WIPER ARM MODIFICATION Prevost vehicles

DESCRIPTION

On the vehicles affected by this bulletin, add an extrusion to the wiper arms to prevent washer fluid hose from pinching

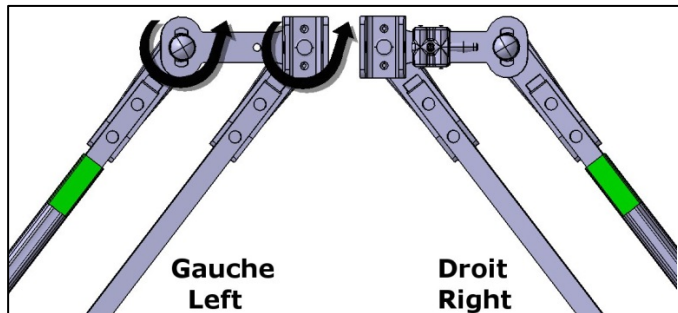
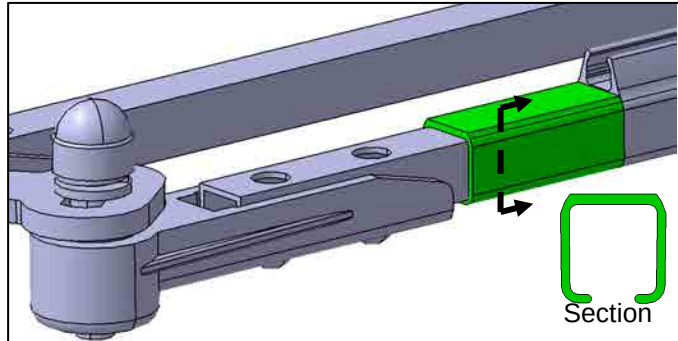
For each wiper parallelogram assembly, install one extruded spacer on the arm having the washing fluid hose 300642 qty 2

Important : Orient as shown, with slot underneath.
